**ARCHITECTURAL
REVIEW COMMITTEE**

ARCHITECTURAL REVIEW COMMITTEE MINUTES MAY 10, 2023

Strand Associates, Inc.® (Strand) has finished its review of the construction drawings and Storm Water & Erosion Control Calculations resubmittal for the Quest Interiors Development that were received from Excel Engineering, Inc. (Excel) on May 22, 2023, for conformance with the Town specifications and general engineering practices. Before construction may begin, the contractor shall submit all required permits for the development to the state, Wisconsin Department of Natural Resources, Town, and any other relevant agencies. New drawings, stormwater management plan and calculations, and a letter describing the revisions should be returned to Strand after the following concerns have been addressed. Excel's responses to Strand's original comments are *italicized* and Strand's most recent comments are in **bold**.

CIVIL GRADING AND EROSION CONTROL PLAN

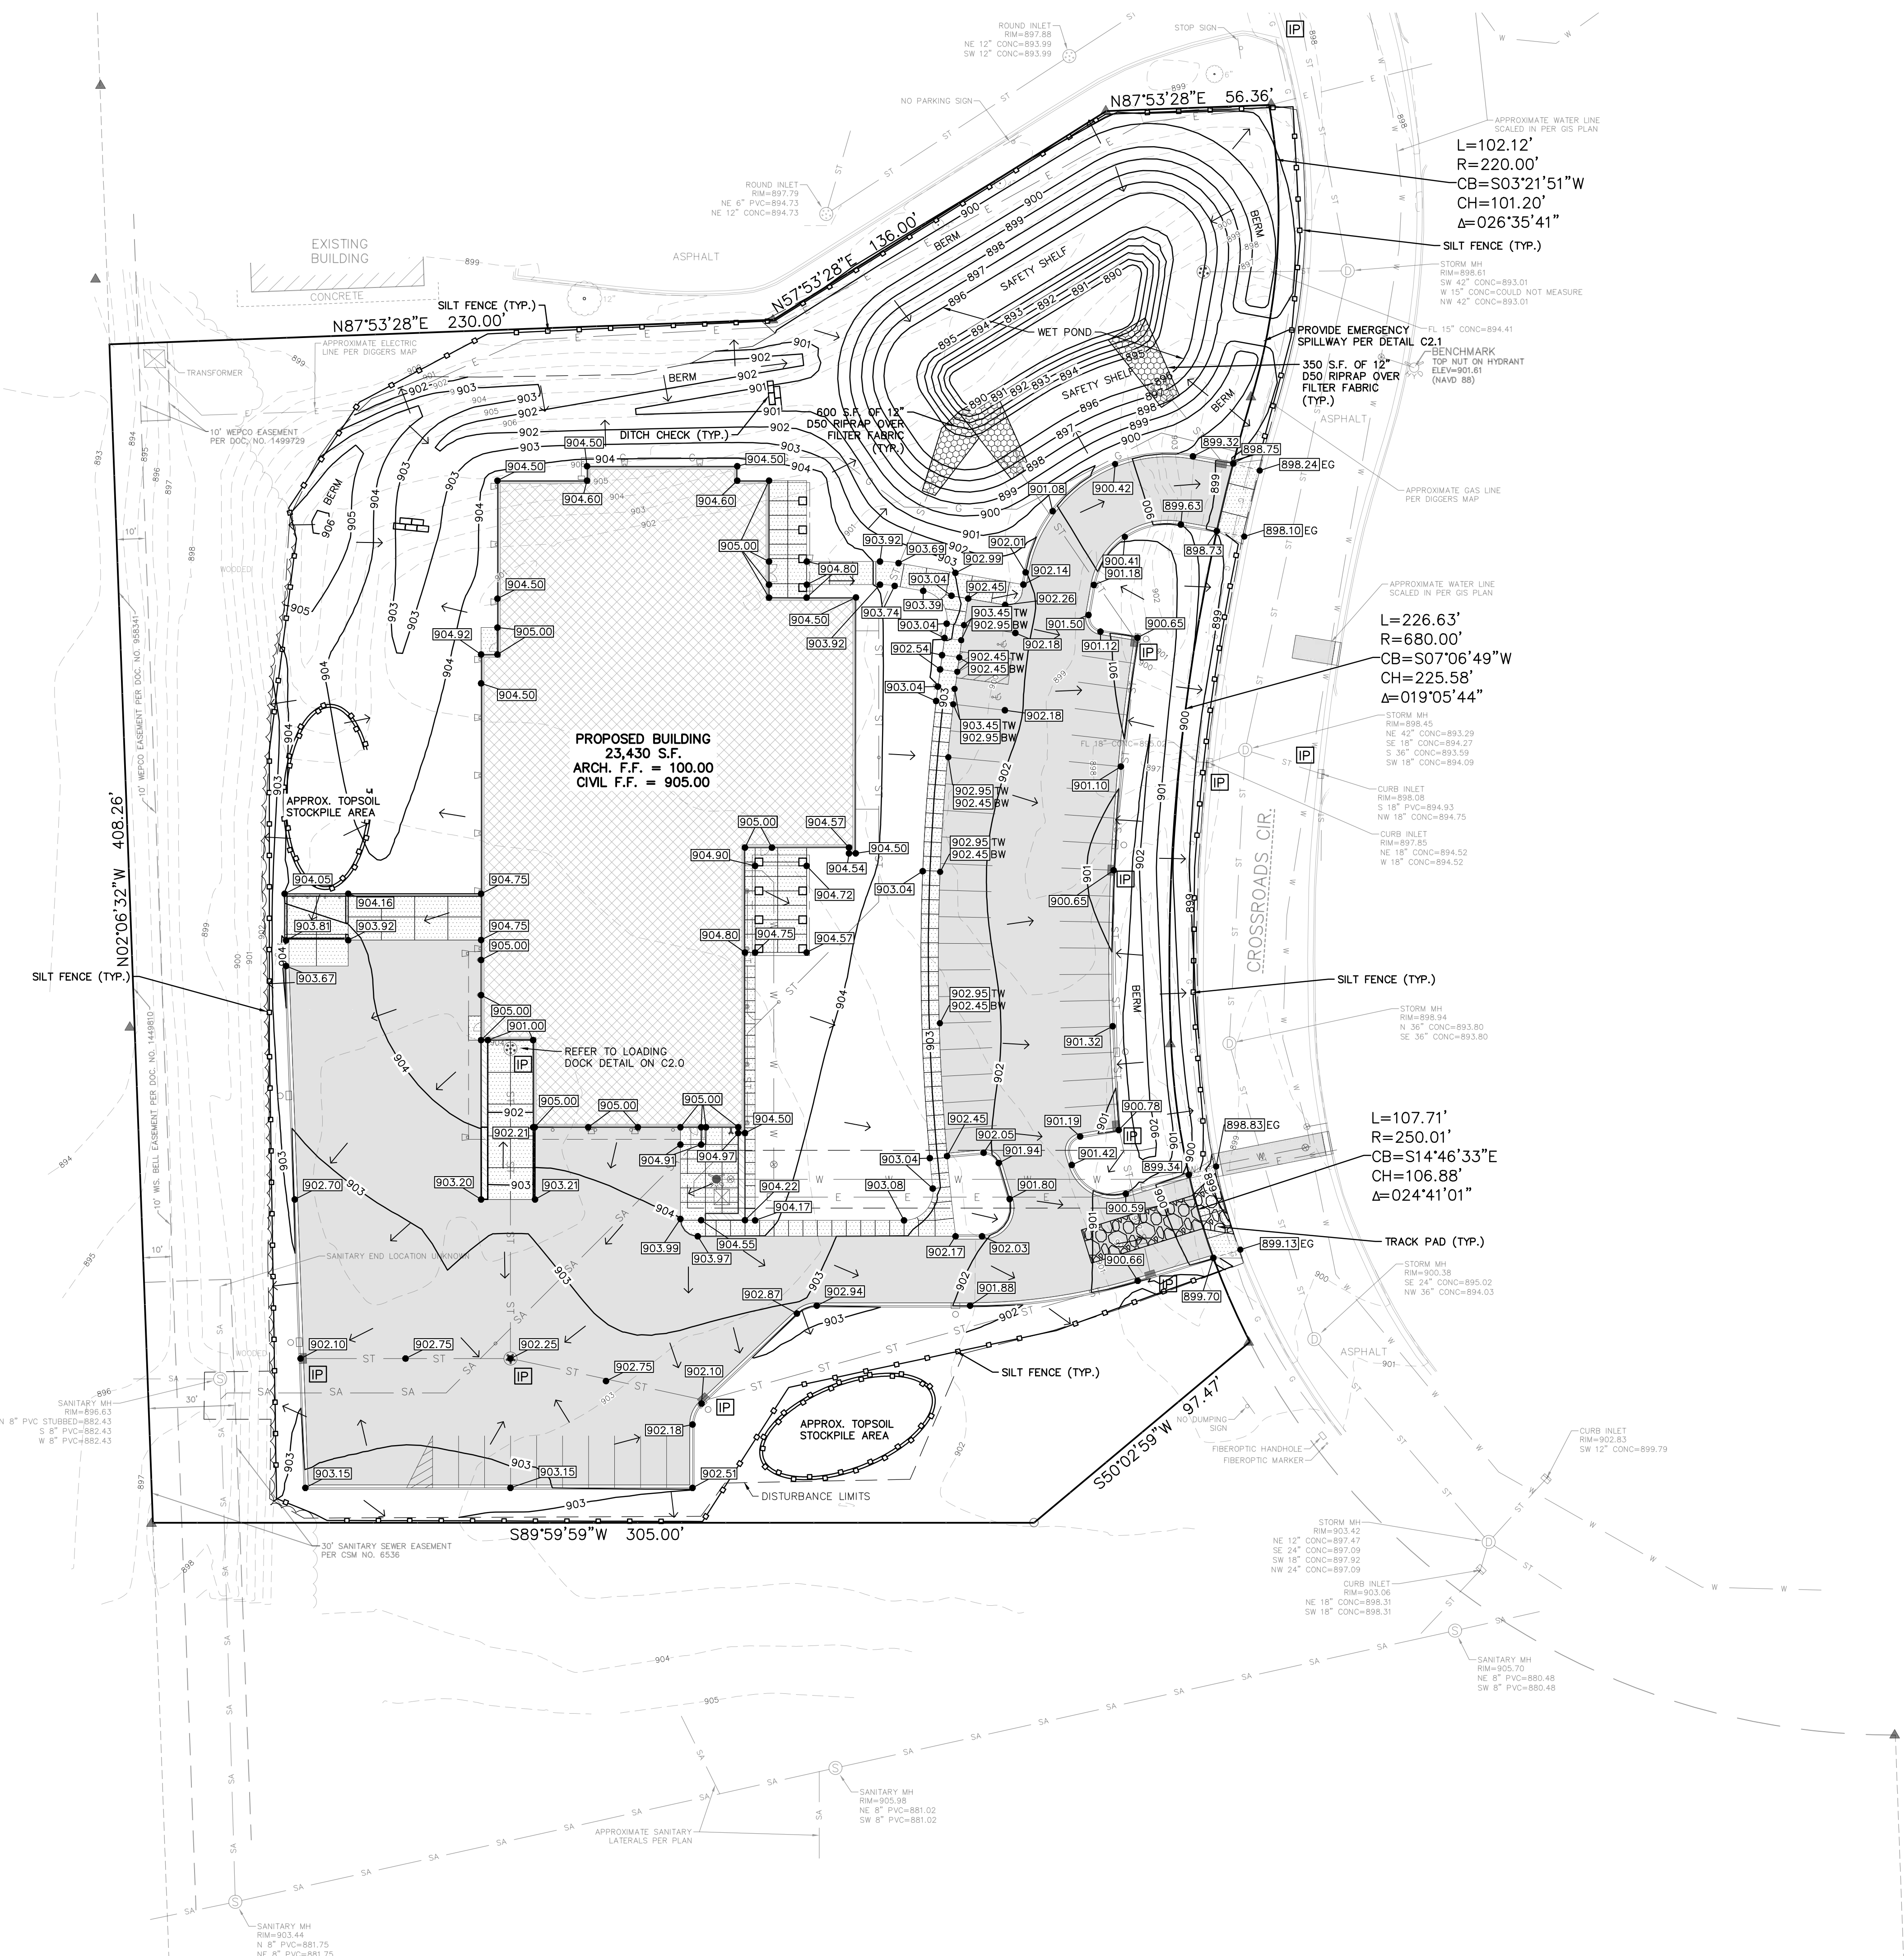
1. Strand’s May 3, 2023, Comment–The anticipated locations of the topsoil stockpiles should be shown on the plan.

2. Strand’s May 3, 2023, Comment–Silt fence should be provided between the two driveway entrances just upstream of the curb line to prevent sediment from washing on to Crossroads Circle.

3. Strand's May 3, 2023, Comment—Safety railings should be provided where the top of wall elevation is more than 30 inches above the adjacent grade according to Section 1013.1 of the Unified Building Code. The top of the retaining wall on the west side of the loading dock ramp. There is a drop of approximately 4 feet from top of the retaining wall on the west side of the loading dock ramp to the bottom of ramp near the building.

4. Strand's May 3, 2023, Comment—The scale bar appears to be incorrect.

Excel’s May 22, 2023, Response–Topsoil stockpile locations have been added to plan sheet C1.2.

Strand’s Current Response–It was verified topsoil stockpile locations are shown on Sheet C1.2 and are in upland areas with two layers of silt fence around the perimeter.

Excel’s May 22, 2023, Response–This has been added to plan sheet C1.2.

Strand’s Current Response–It was verified silt fence was added at this location.

Excel's May 22, 2023, Response—The architectural plans will cover this scope and requirement.

Strand's Current Response—The architectural committee should review the plans to verify requirements are met.

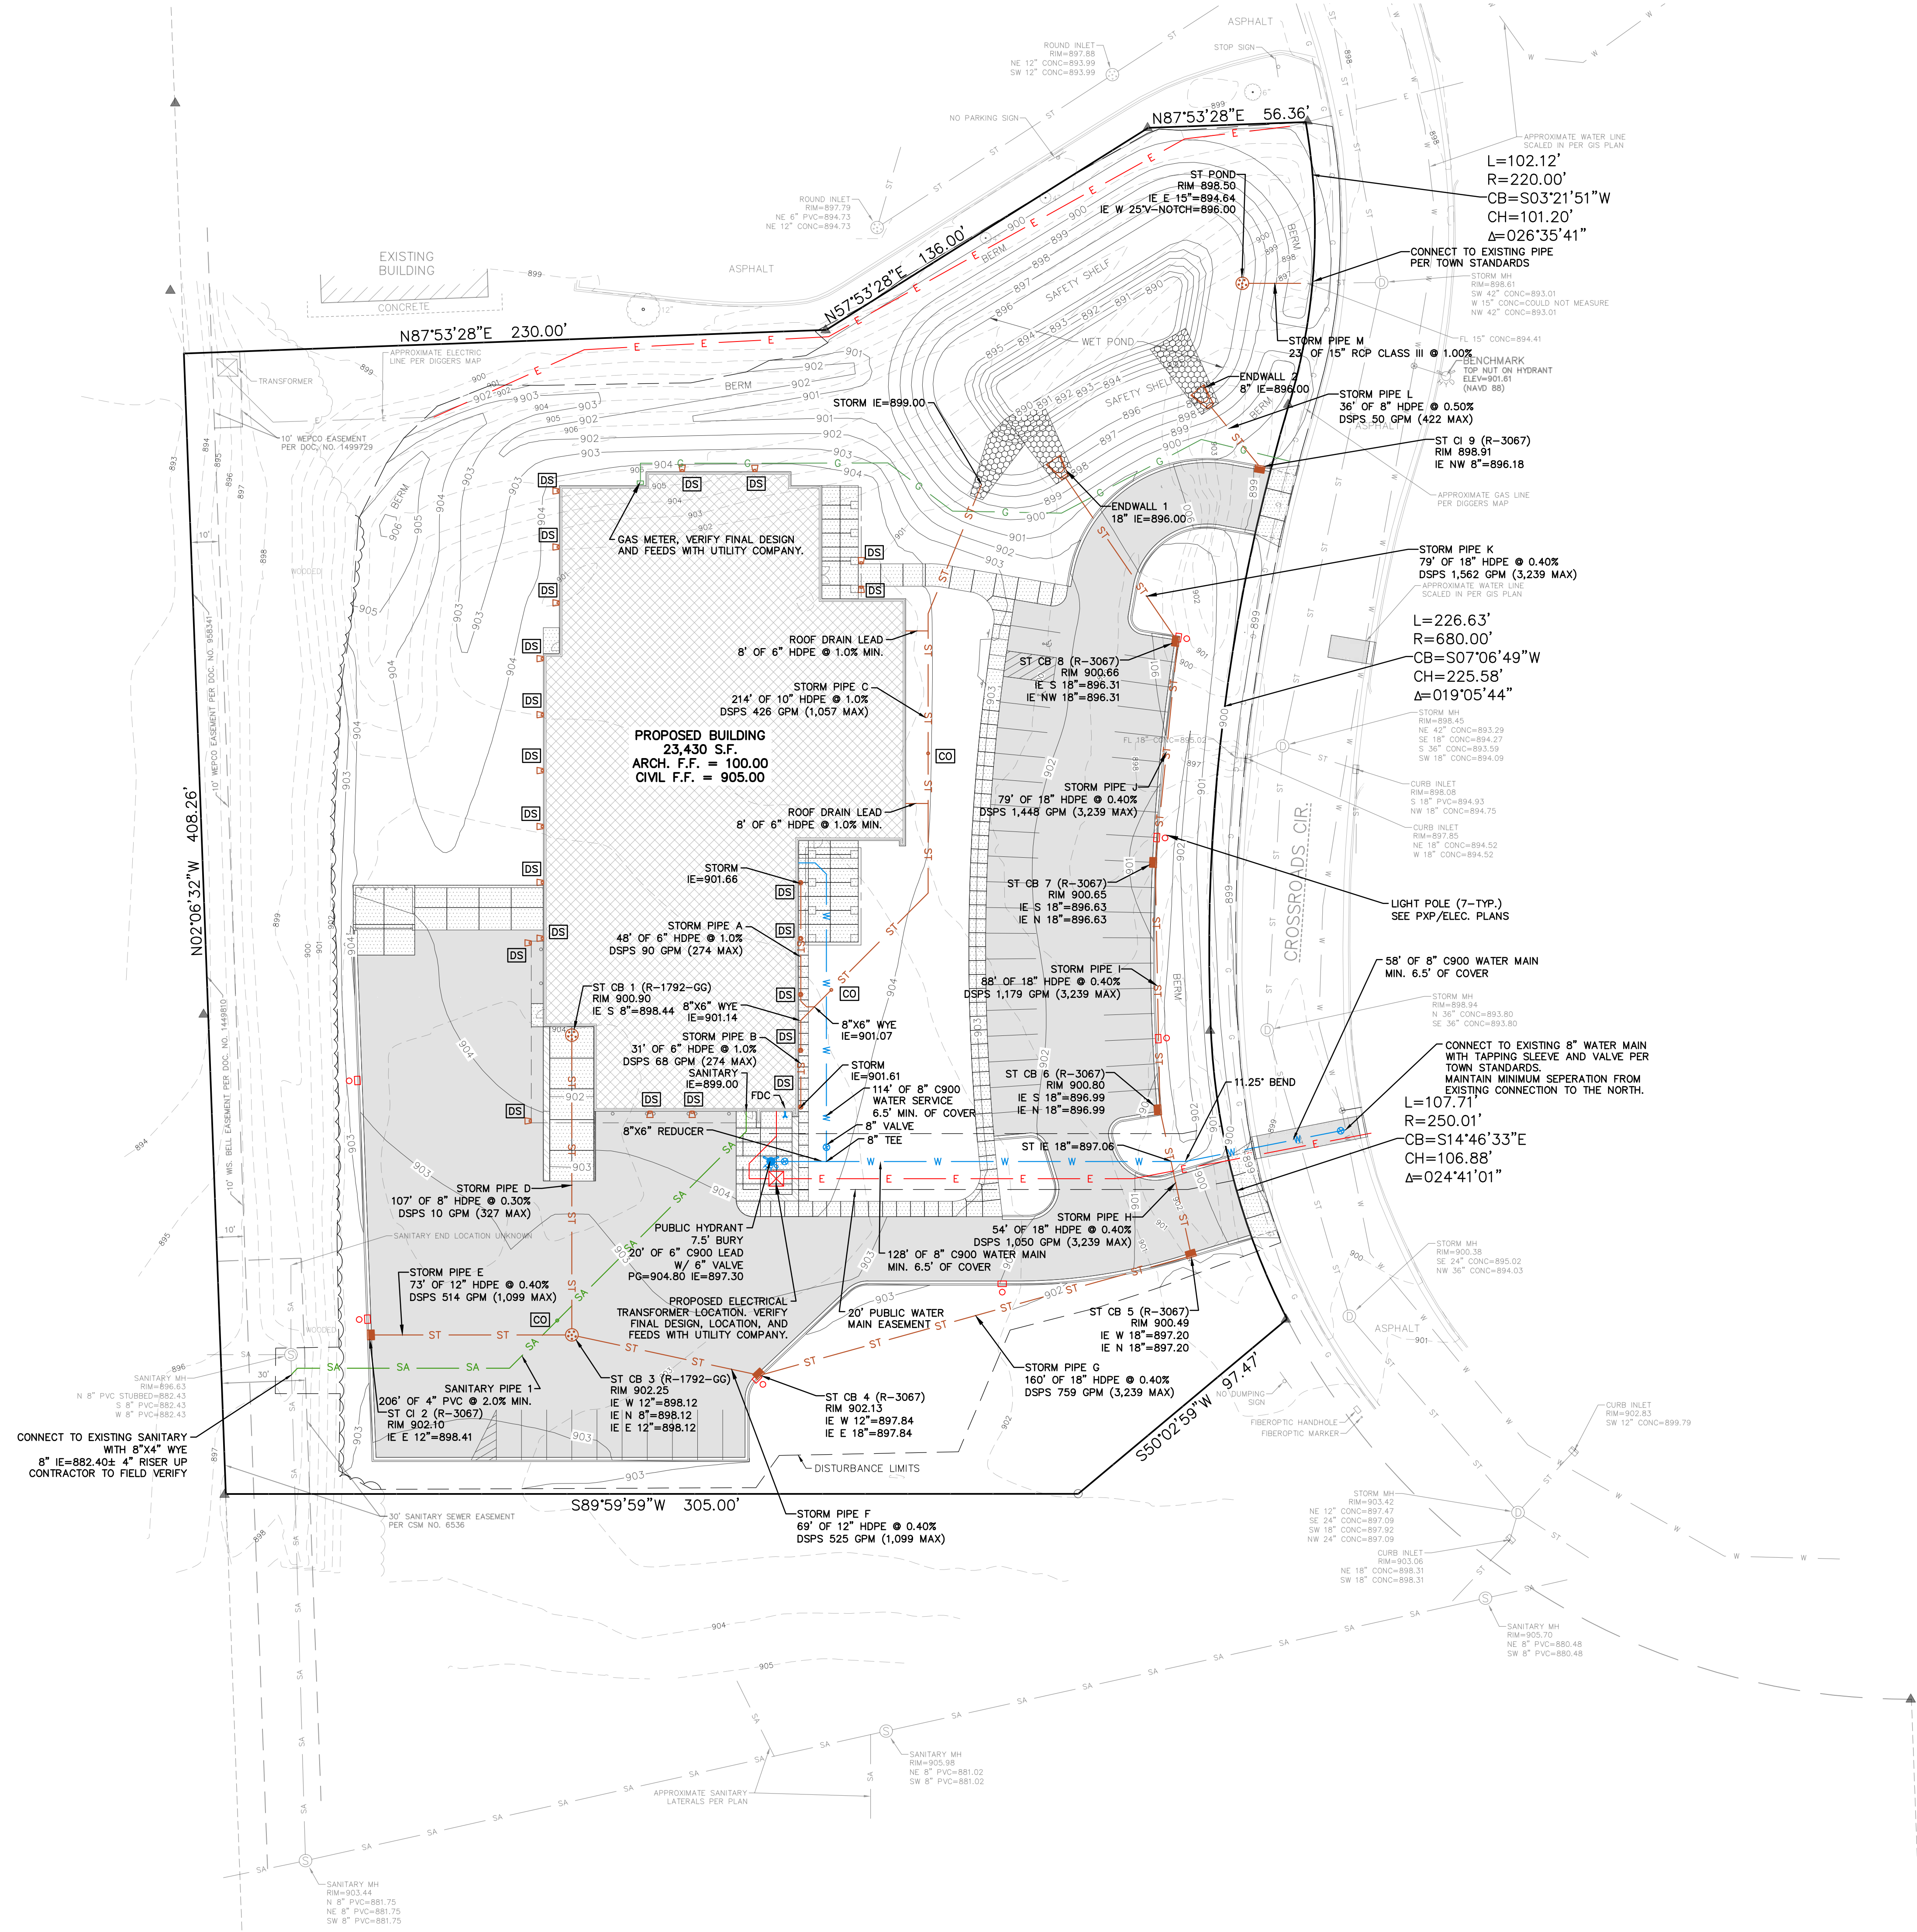
1. Strand's May 3, 2023, Comment—The callout for the rim elevation of CB-1 (901.12) does not match the callout for the rim elevation shown in the Bay Loading Dock Detail (900.90).

2. Strand's May 3, 2023, Comment—Evaluate that proper separation between water, storm, and sanitary sewer mains are meeting the requirements of Section NR 811.74 of the Wisconsin Administrative Code (WAC).

3. Strand's May 3, 2023, Comment—The storm sewer structure and casting types should be called out on the plan.

4. Strand's May 3, 2023, Comment—Review that all water main design meets the requirements of Section NR 811.70 of WAC and Section 12 of the Town Sanitary District No. 4 technical specifications (see Sections 12.1—Water Main Material, 12.2—Valve Type, 12.3—Pipe Cover and length requirements, 12.5—Thrust Restraint, and 12.18—Fire Hydrant Type). Supporting documentation should be provided.

5. Strand's May 3, 2023, Comment—It should be noted that, before water utility construction can begin, a modification to the water service application will need to be submitted to the Town and, if plumbing fixtures are being added, calculations should be provided for proper meter sizing.

6. Strand's May 3, 2023, Comment—A note should be added stating that the contractor shall notify the Town Sanitary District No. 4 and field staff a minimum of 72 hours before the start of any construction or connection to existing public utilities.

7. Strand's May 3, 2023, Comment—The existing sanitary sewer is not shown correctly on the west side of the property where the proposed sanitary service connection to the main is taking place. The sewer main is entering the manhole from the west and then heads south. There is no sewer line running north of this manhole (see enclosed markup). This will require a modification of the proposed sewer service connection to the main.

8. Strand's May 3, 2023, Comment—A 6-inch water valve should be added to the proposed water service (see enclosed markup).

9. Strand's May 3, 2023, Comment—The proposed water main tapping location is near an existing water service connection. A note should be added stating the required distance from the existing connection.

Excel's May 22, 2023, Response—The rim elevation on C1.3 for ST CB 1 has been revised to match the detail.

Strand's Current Response—It was confirmed that elevations now match on both sheets.

Excel's May 22, 2023, Response—A minimum separations are maintained throughout the design.

Strand's Current Response—It appears the proper separation distance between water and storm crossings are maintained.

Excel's May 22, 2023, Response—Abbreviation designations are on the plan sheet to correspond to detail on C2.1.

Strand's Current Response—It was verified casting types are called out for each structure.

Excel Response: Design requirements are met and notes and details have been added to the plans.

Strand's Current Response—It was verified notes and details were added to the construction drawings.

Excel's May 22, 2023, Response—This note has been included on plan sheet C1.3.

Strand's Current Response—It was verified that the note was added to Sheet C1.3.

Excel's May 22, 2023, Response—This note has been included on plan sheet C1.3.

Strand's Current Response—It was verified that the note was added to Sheet C1.3.

Excel's May 22, 2023, Response—The sanitary lateral location has been modified based on this information.

Strand's Current Response—The existing sanitary sewer line north of the manhole is still shown. This does not exist and should be removed. It should be verified that the proposed 4-inch-diameter lateral has adequate capacity to handle proposed loadings.

Excel's May 22, 2023, Response—The water service location has been revised and a valve has been added to plans.

Strand's Current Response—It appears that the fire hydrant and valve will be located behind a masonry wall and near an electrical transformer. It should be verified there is enough room for access by the fire department and Town Sanitary District No. 4 for emergency situations and maintenance.

Excel's May 22, 2023, Response—The connection note on plan sheet C1.3 has been revised to reflect this.

Strand's Current Response—It was verified that a note was added regarding maintaining the minimum separation distance from the existing connection.
